APPEAL SUMMARY

Appeal ID: 18957	Project Address: 820 SE Alder St
Hearing Date: 2/6/19	Appellant Name: Iain MacKenzie
Case No.: B-009	Appellant Phone: 5032200668
Appeal Type: Building	Plans Examiner/Inspector: Maureen McCafferty
Project Type: commercial	Stories: 10 Occupancy: R-2, A-2, A-3, S-2, B Construction Type: Type I-B
Building/Business Name: Alder.9	Fire Sprinklers: Yes - Throughout
Appeal Involves: Erection of a new structure	LUR or Permit Application No.: 18-261126-CO
Plan Submitted Option: pdf [File 1] [File 2]	Proposed use: Residential / Retail

ALDER.9TH
820 SE ALDER ST.

1 LEVEL 04 - 09 FLOOR PLAN
1/8" = 1'-0"

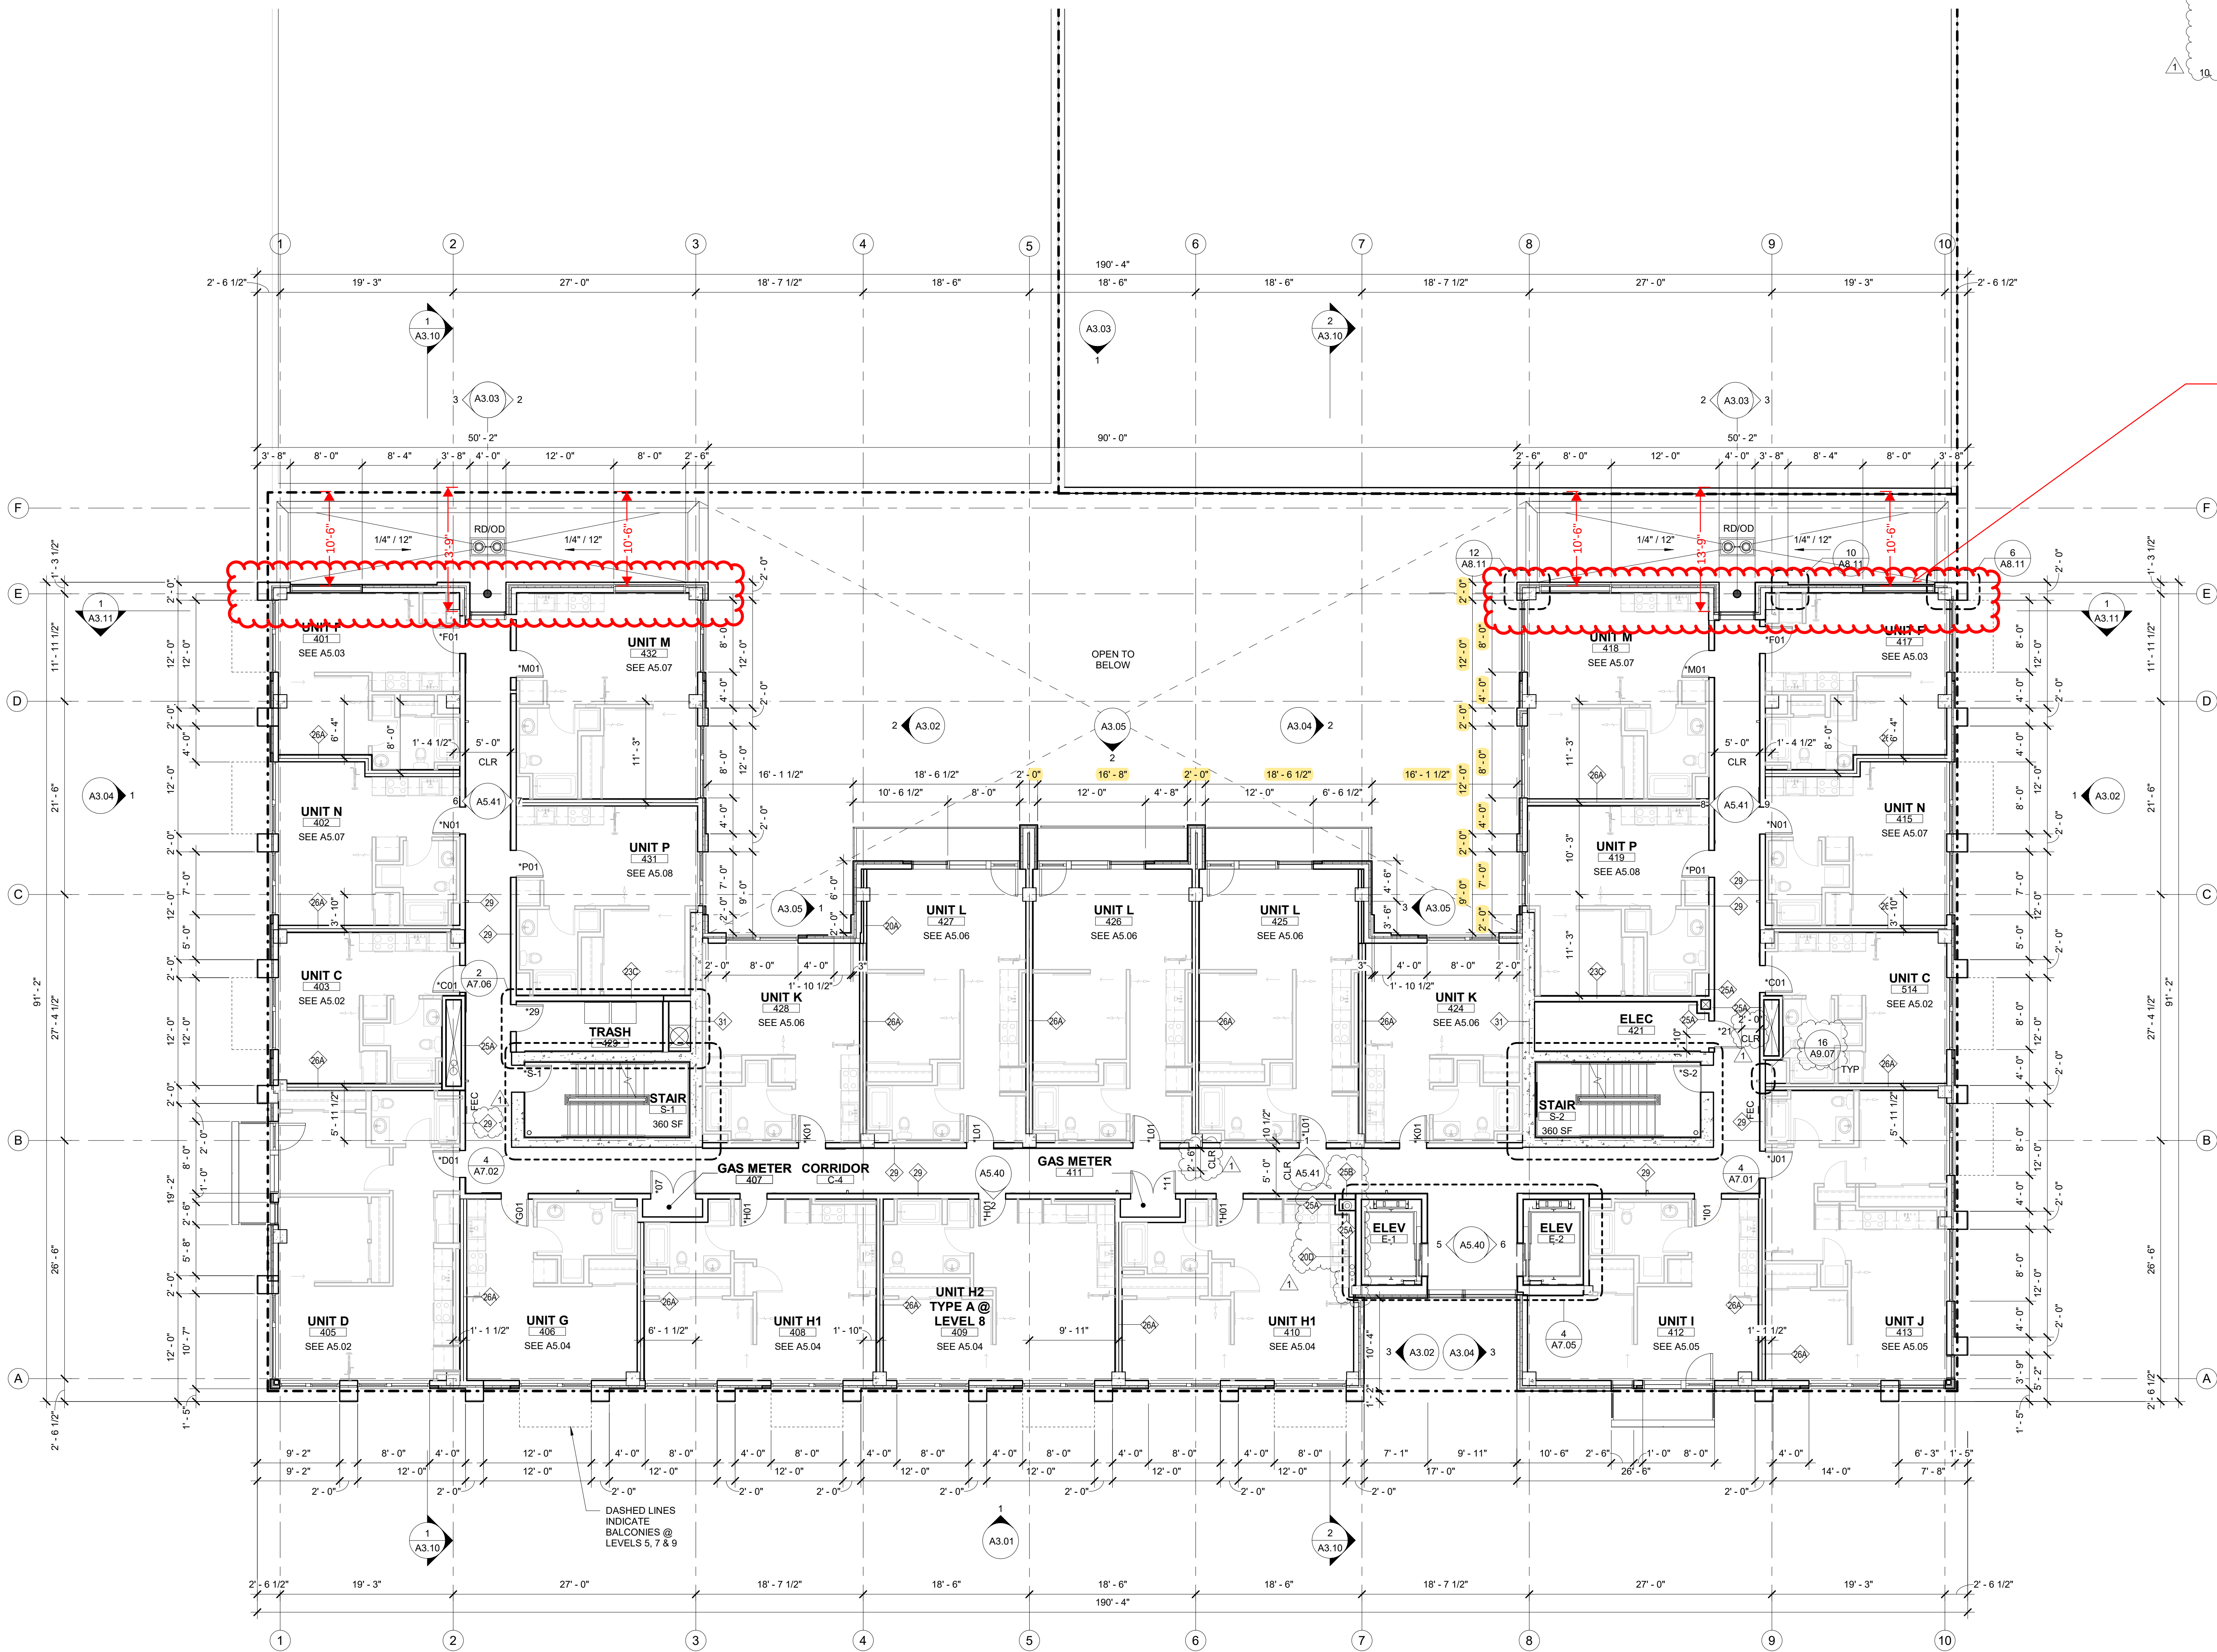
Proposed Design Windows subject to this requirement are located on the west elevation at levels four and five, at the corridor end walls and in units 401, 417, 418, 432, 501, 517, 518 and 532.

Instead of providing fire rated glazing it is proposed make the windows non-operable, with additional sprinkler protection. Sprinkler heads are to be spaced not more than 6 feet apart and placed a minimum of 6 inches and a maximum of 12 inches from the opening(s) and a maximum of 12 inches below the ceiling. Sprinklers are to be installed on the occupied side of the openings and are to be capable of wetting the entire window surface.

APPEAL ITEM #3 -
VERTICAL EXPOSURE FOR
WINDOWS ON WEST
ELEVATION AT LEVELS 4
AND 5

3. Type 13 water curtain sprinkler protection at non-fire rated openings in buildings with vertical exposure on separate lots: Granted provided windows are non-operable and sprinklers are spaced not more than 6 feet apart and placed a minimum of 6 inches and a maximum of 12 inches from the opening(s) and a maximum of 12 inches below the ceiling. Sprinklers are to be installed on the occupied side of the openings. A separate permit from the Fire Marshal's Office is required.

L01 LOBBY
COMPOSITE
SHEET

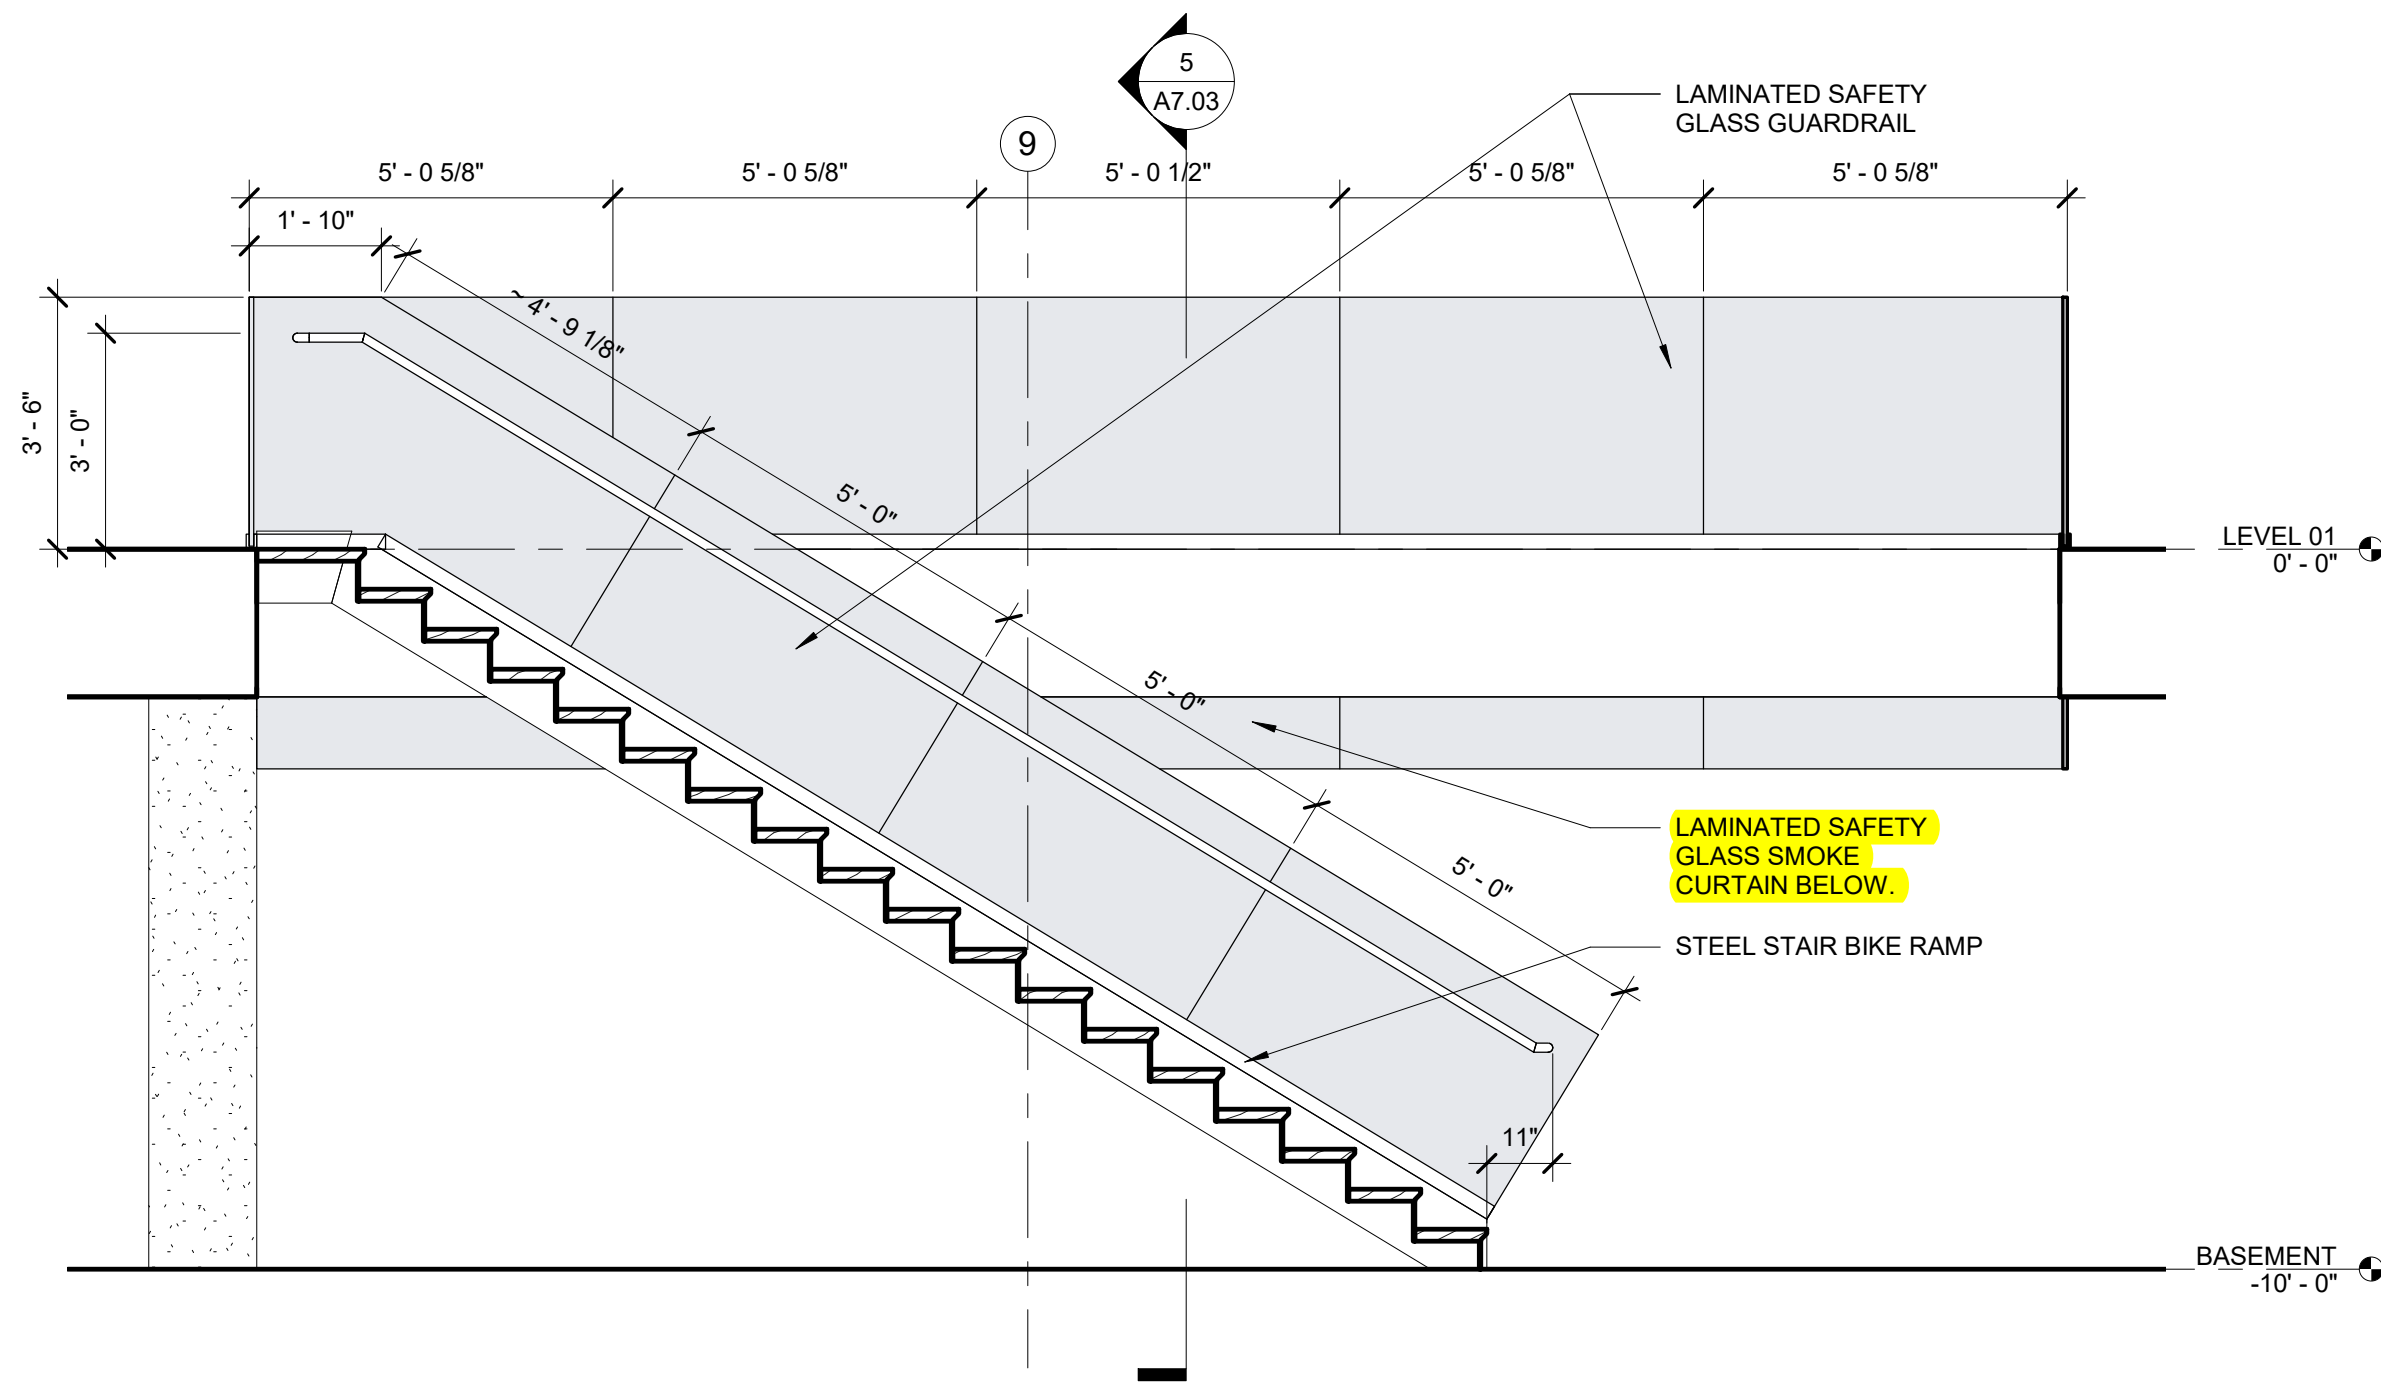
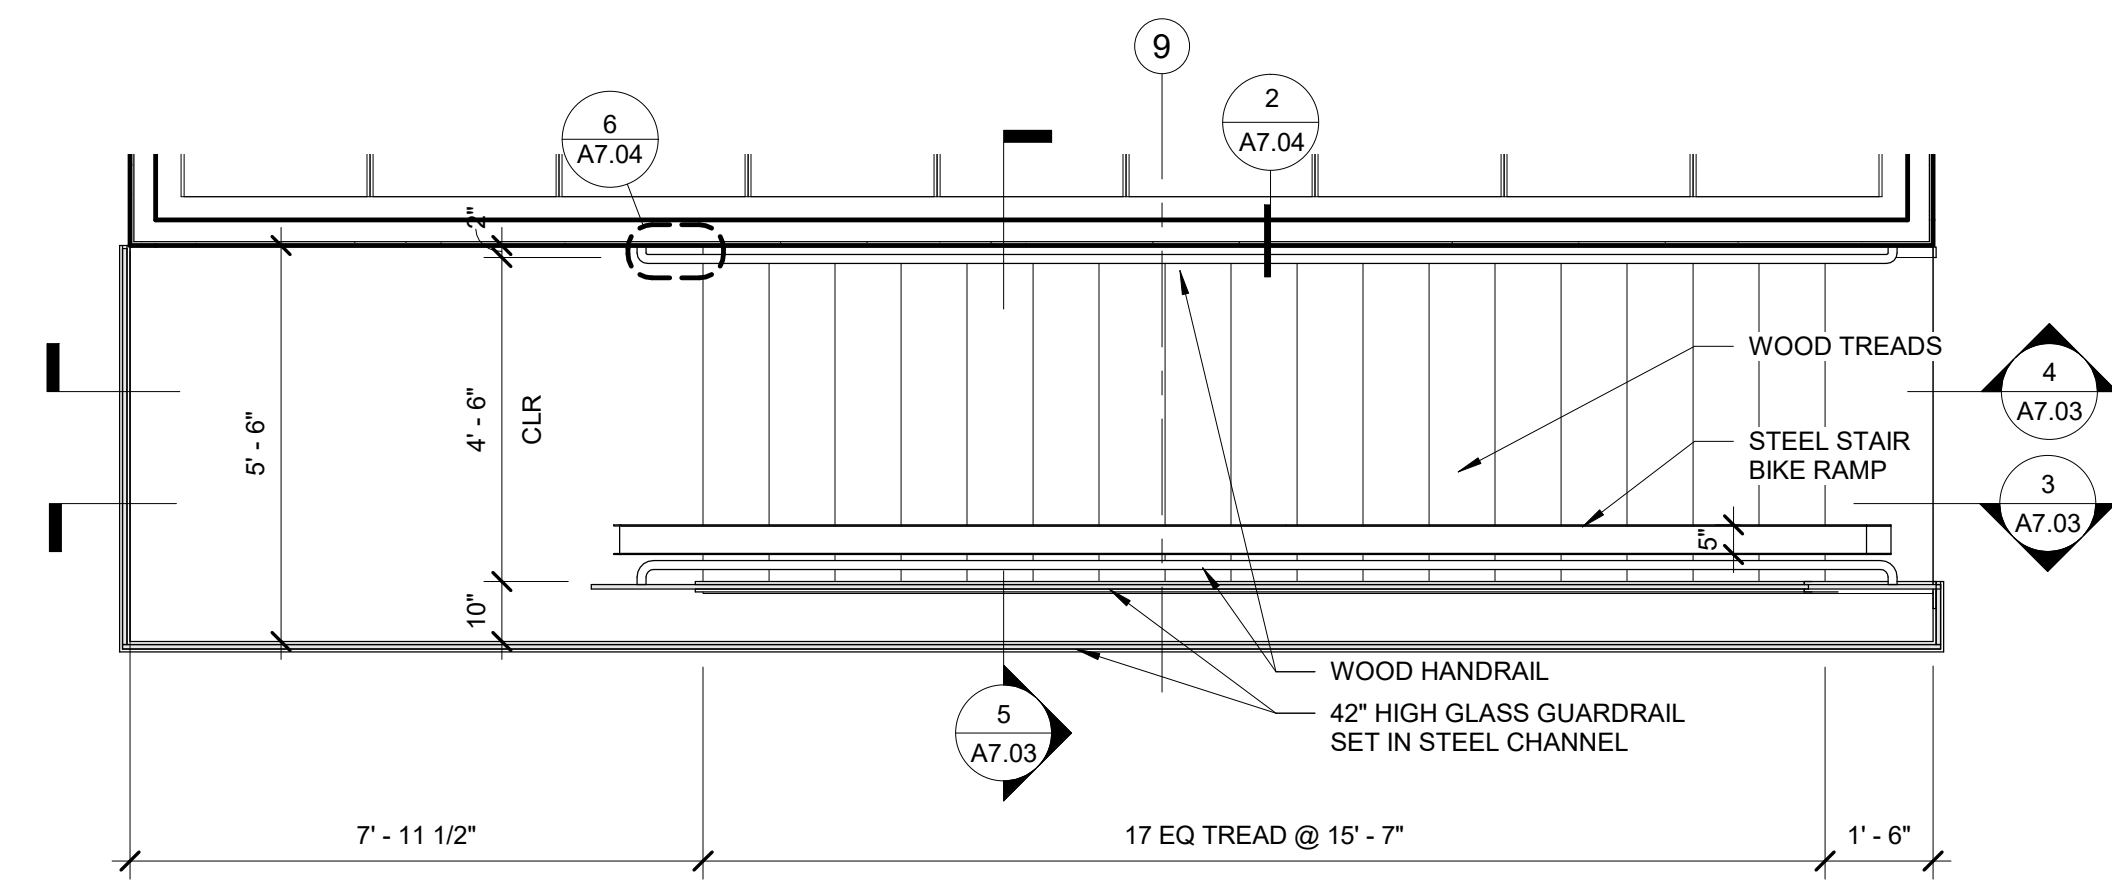
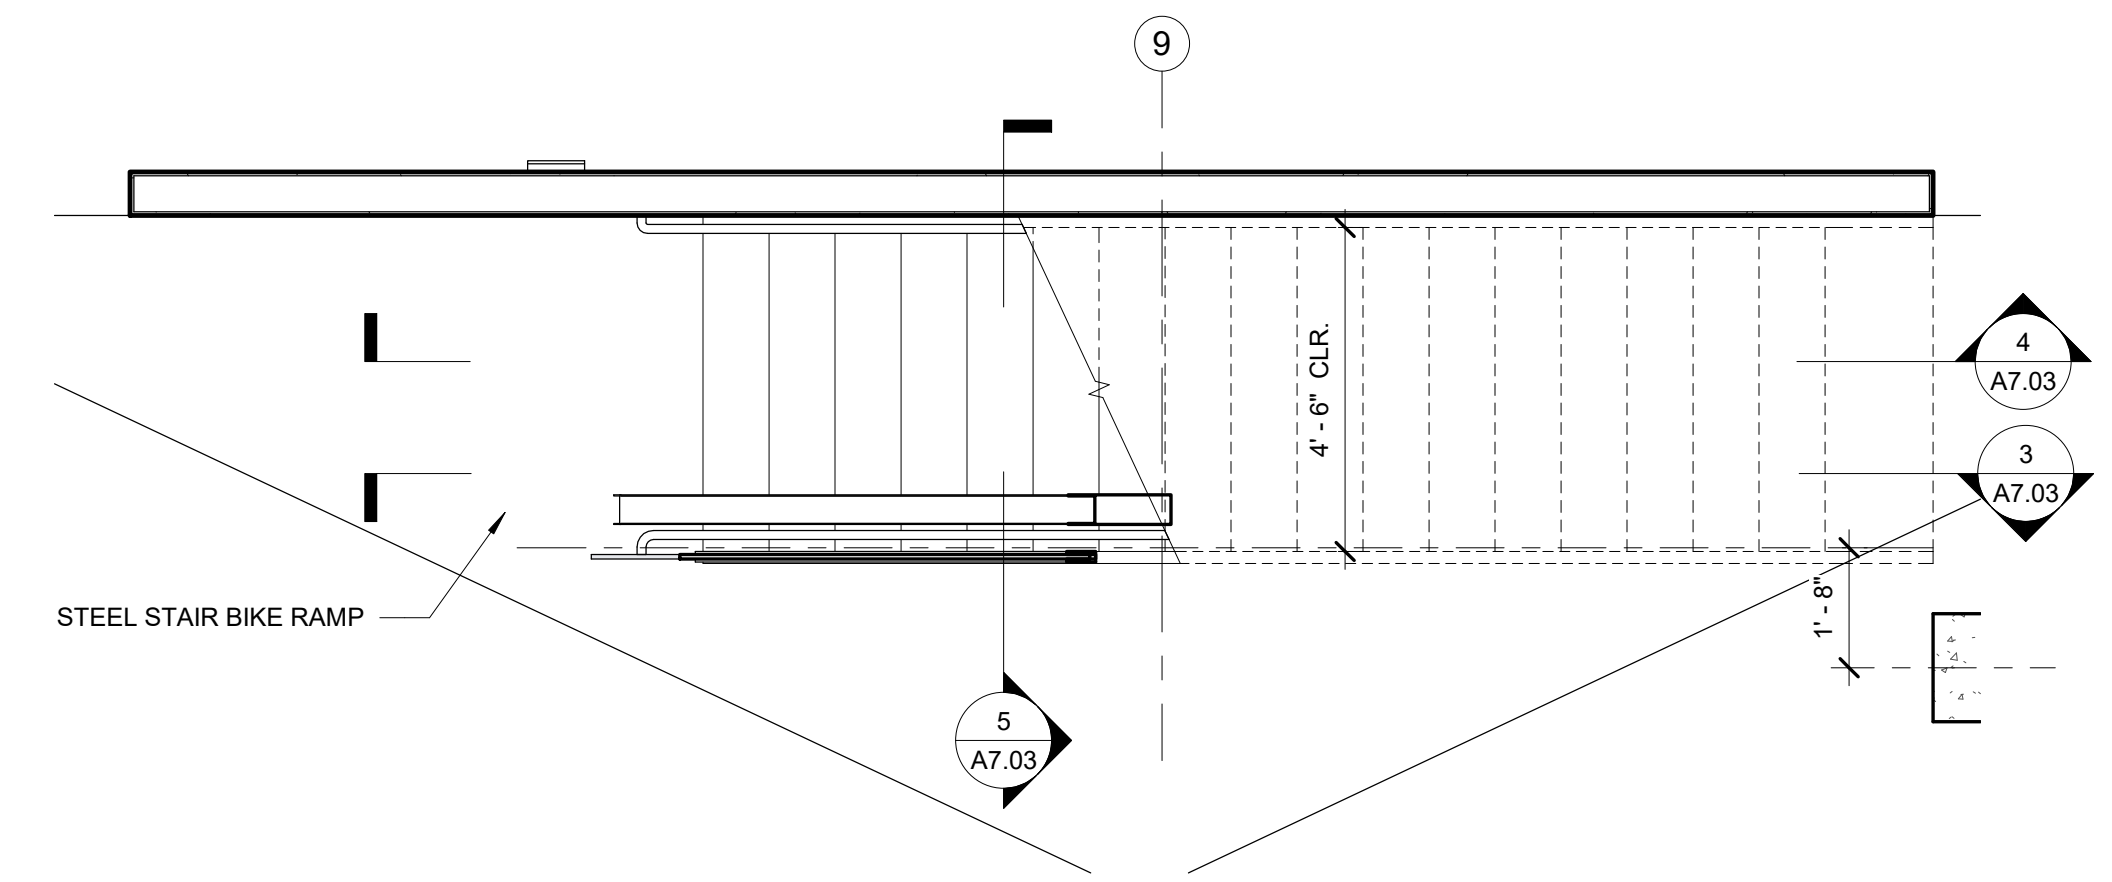
- b) The open stair connects the lobby to a small, low hazard space, which is separated from the rest of the basement by fire barriers. All spaces are fully sprinkled. Should a fire break out in any other part of the basement it would be prevented from spreading to the dog wash by the combination of sprinklers and fire barriers.

In the event of a fire in the dog wash room the opening in the level 1 slab is protected with laminated glass smoke curtains, which would prevent smoke from traveling from the dog wash room to the lobby.

RECESSED MAILBOXES AND PACKAGE STORAGE ROOM

APPEAL ITEM #2B - EXIT
DISCHARGE.

OPEN STAIR TO LEVEL
BELOW

2b. Separation of exit discharge from areas below: Granted as proposed.
